VIRTUAL MEETING OF THE BIRMINGHAM PLANNING BOARD
WEDNESDAY, MAY 26, 2021
7:30 PM

SUBJECT: 239 N. Old Woodward – Bloom Bistro – Special Land Use Permit, Final Site Plan & Design Review

SUBJECT: 115 Willits – Mare Mediterranean – Special Land Use Permit, Final Site Plan and Design Review

FLOOR PLANS

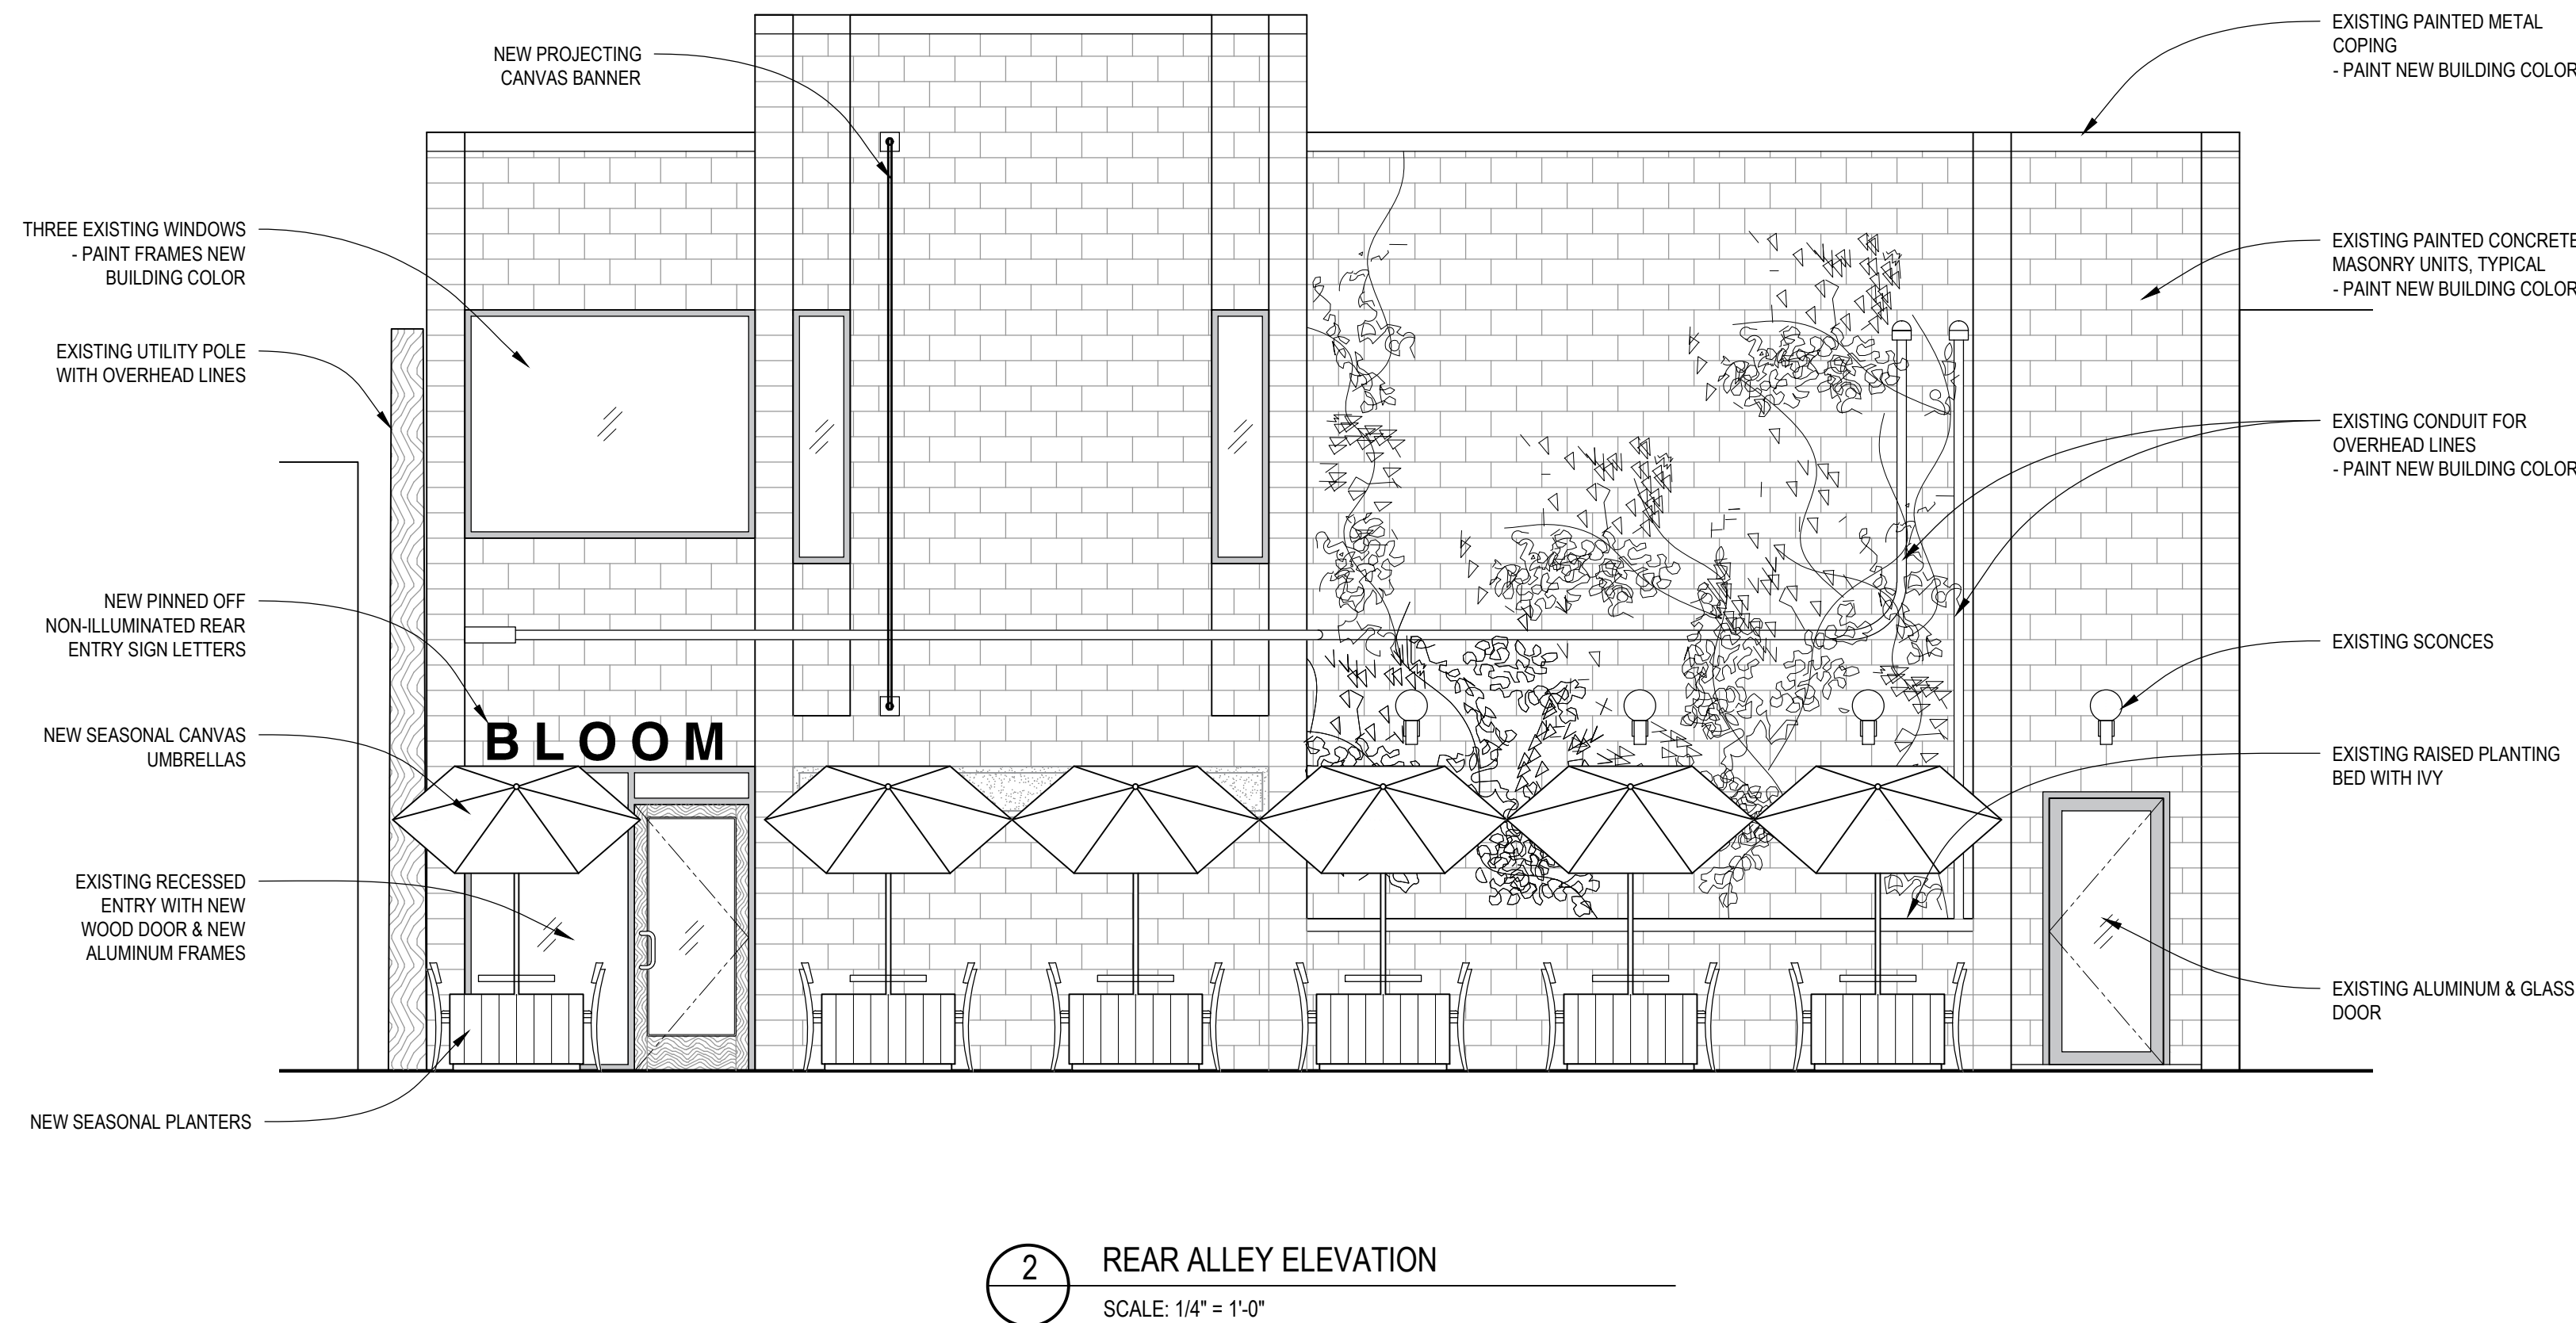
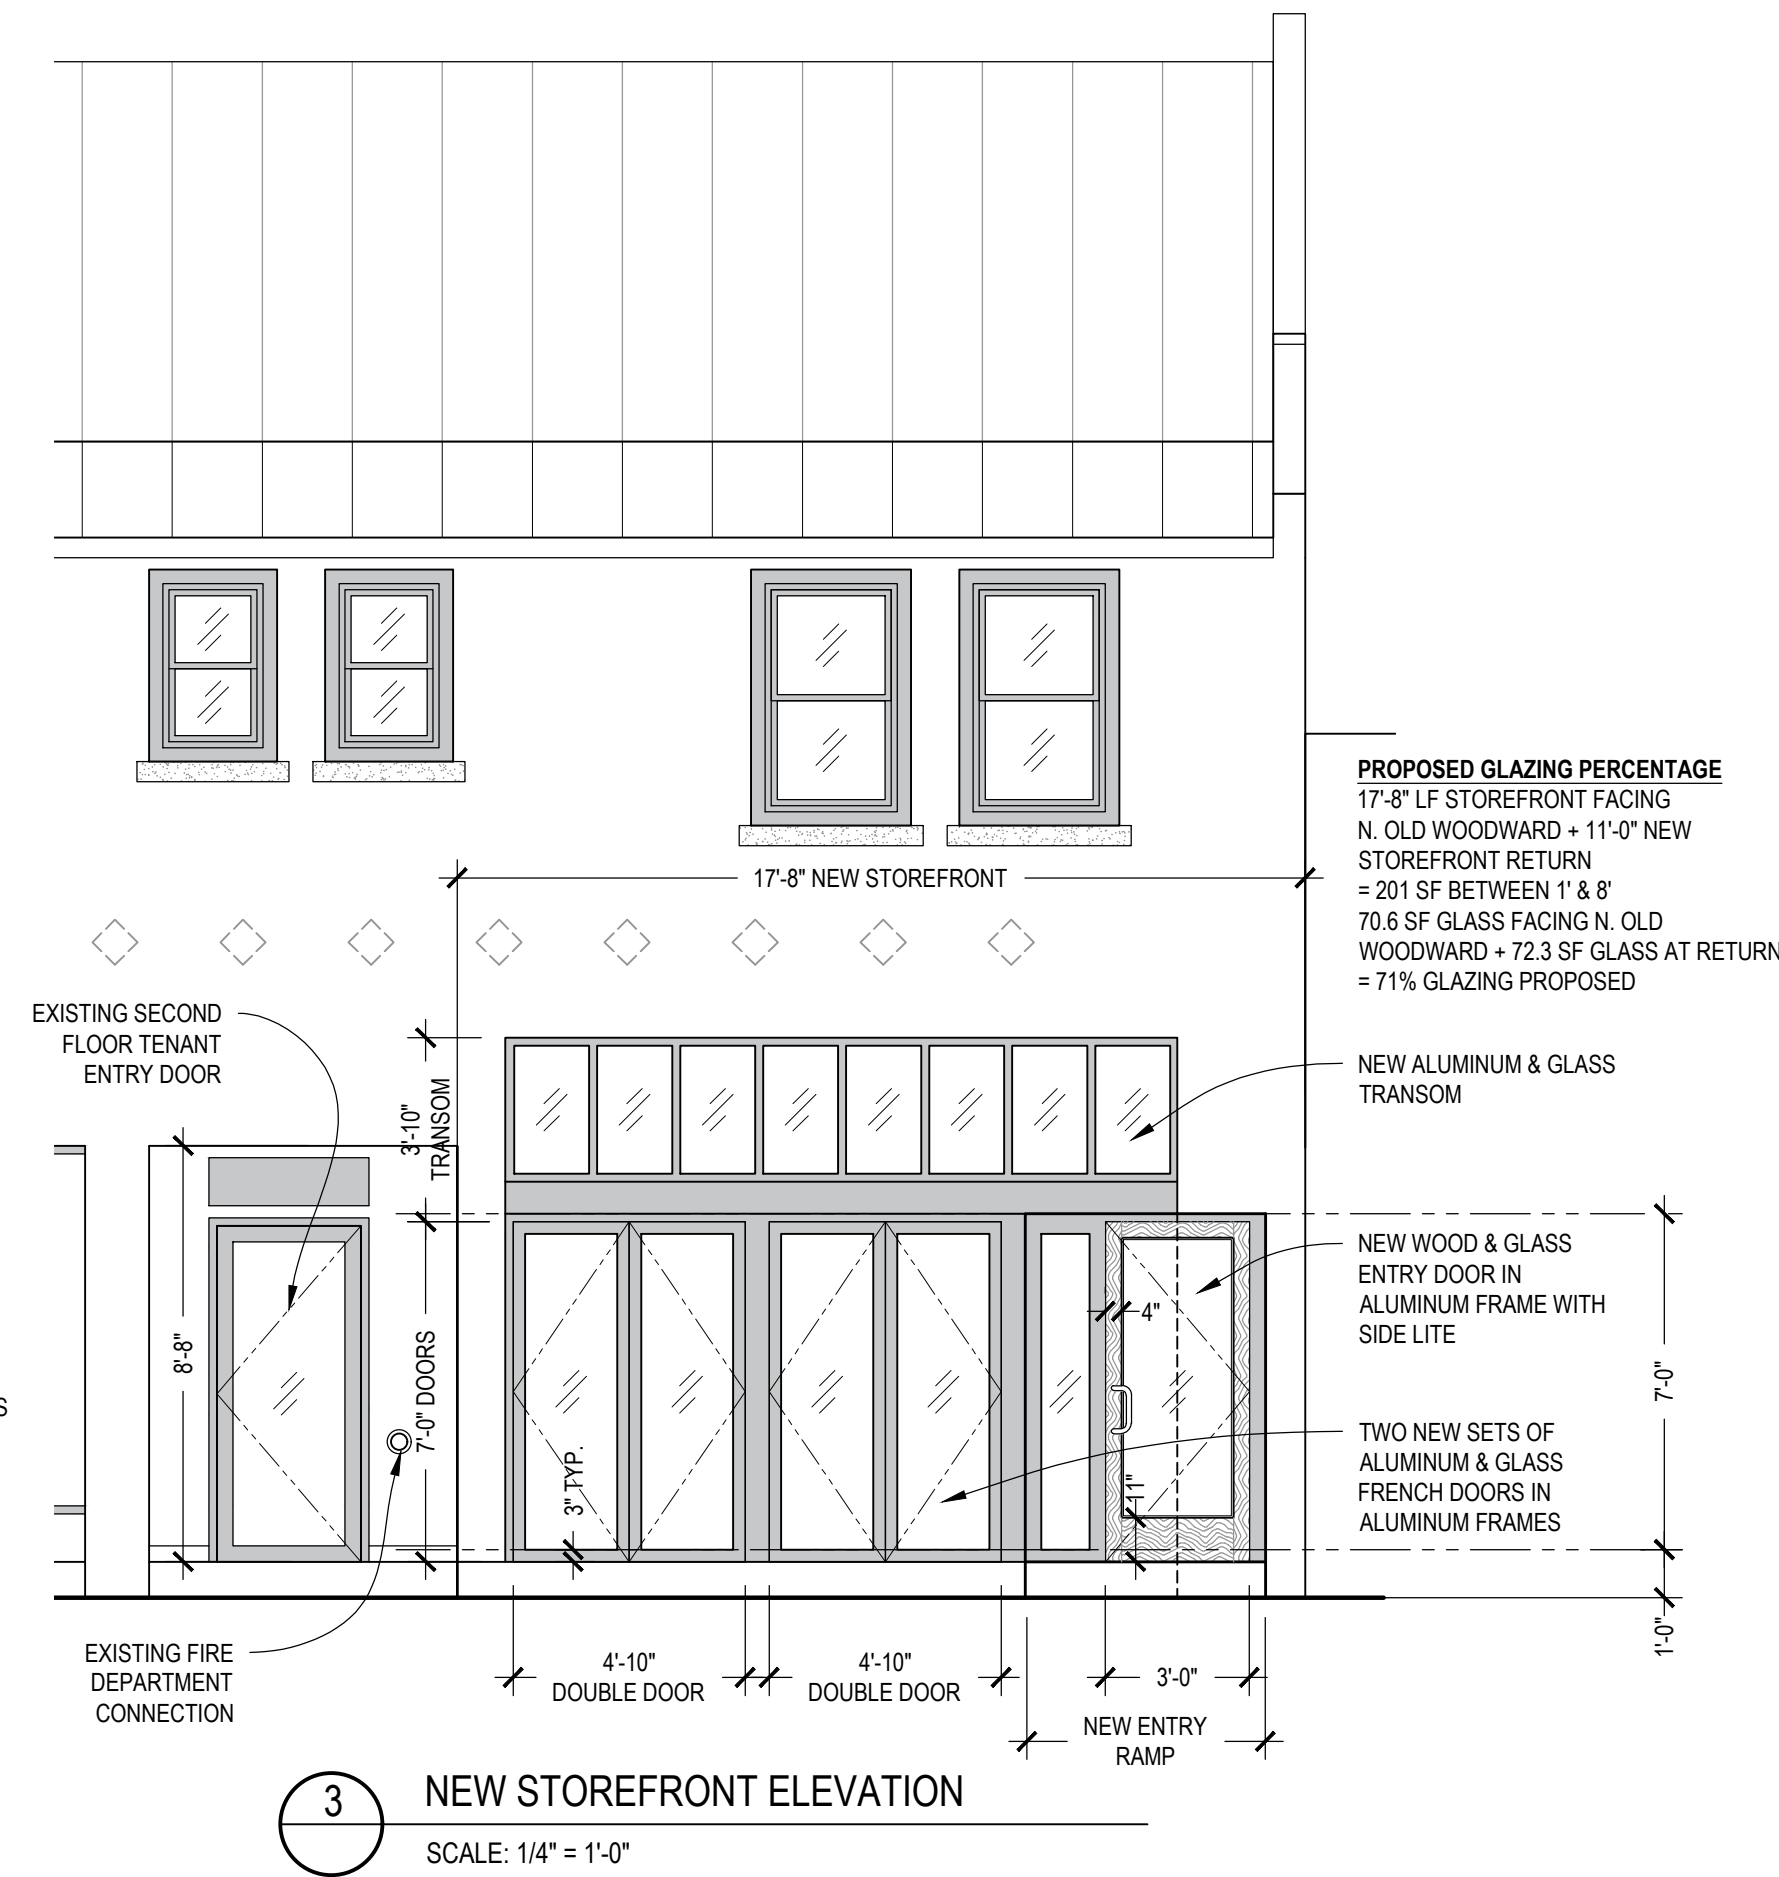
As noted above, the applicant is proposing to rework the entire storefront and add new glazing, which requires them to meet the glazing requirements outlined in Article 3, Section 3.04 of the Zoning Ordinance. The New Storefront Elevation drawing shown on sheet A-2 contains a calculation showing that the new storefront contains 71% glazing in between 1 ft. and 8 ft. from grade. However, the applicant has not submitted specification sheets on any proposed glazing to ensure that the clarity requirements of 80% VLT are met. **The applicant must submit specification sheets with Visual Light Transmittance figures for all proposed glazing.**

In summation, **the applicant must revise the sign concept for Bloom to meet the dimensional requirements of the Sign Ordinance**
